Addendum No. 1

Subject: **Bid No. 23-24.18**; SP-4269; CDBG ADA Wheelchair Access Ramp Replacement Project

IMPROVEMENTS PLAN
CDBG FY23-24 ADA RAMP REPLACEMENT
RAMP DETAILS

IMAGE 1: EXISTING TREE AT 307 E JACARANDA
4" DIAMETER TRUNK

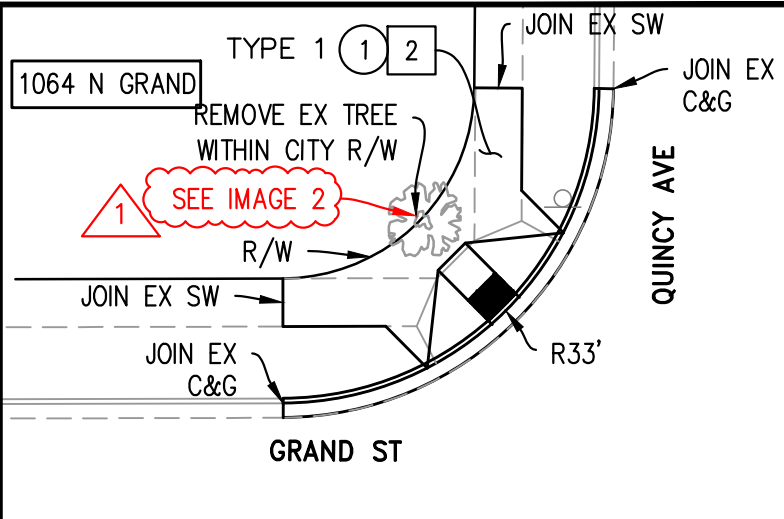
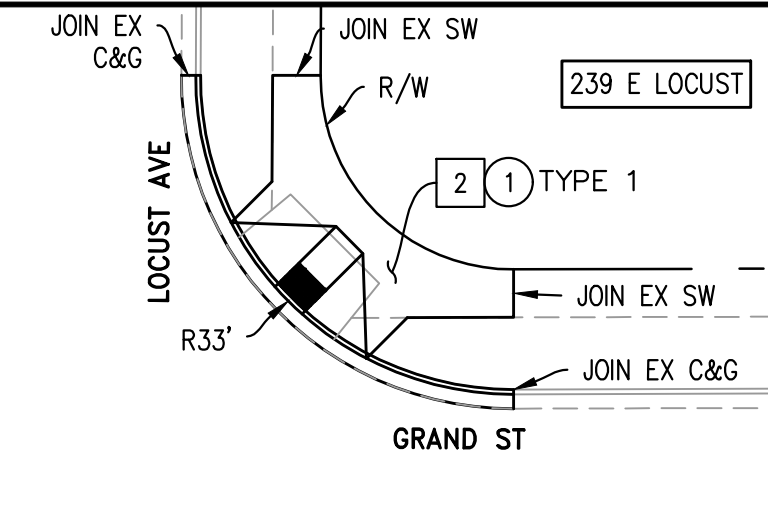
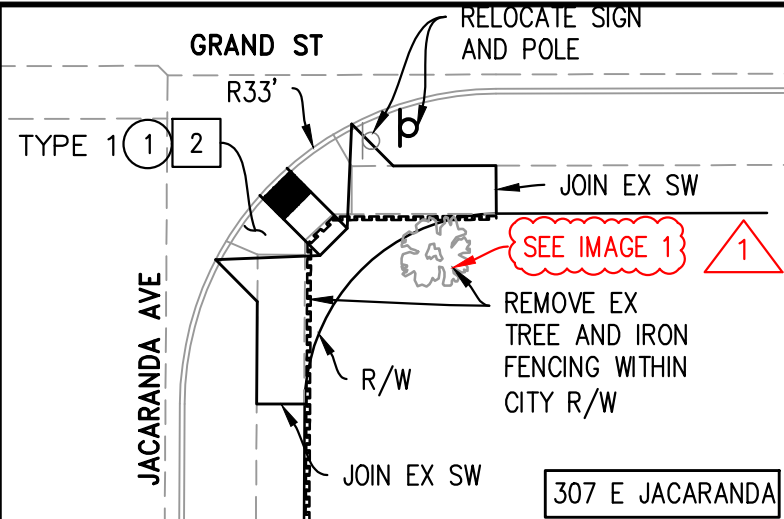
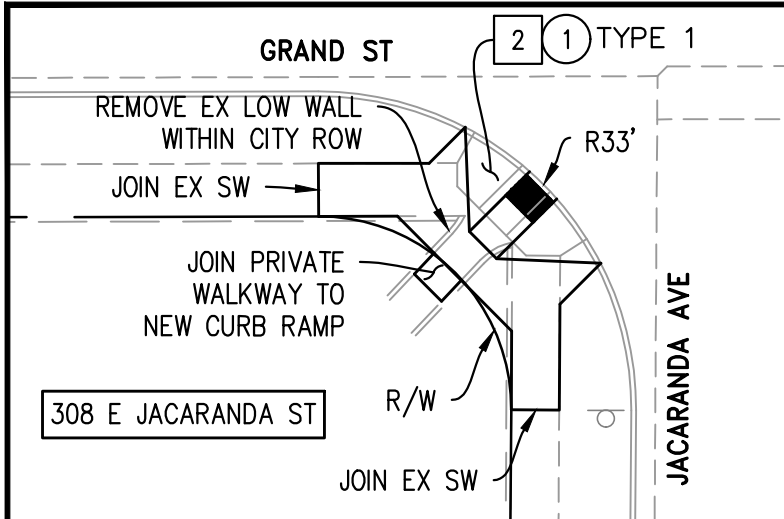
1. Plan sheet revised to include photos of the existing trees to be removed and tree trunk sizes.

ADDENDUM 1: ADDED PHOTOS OF TREES TO BE REMOVED AND TRUNK DIAMETERS FOR EACH.

IMAGE 2: EXISTING TREE AT 1064 N GRAND
20" DIAMETER TRUNKS (BOTH SAME SIZE)
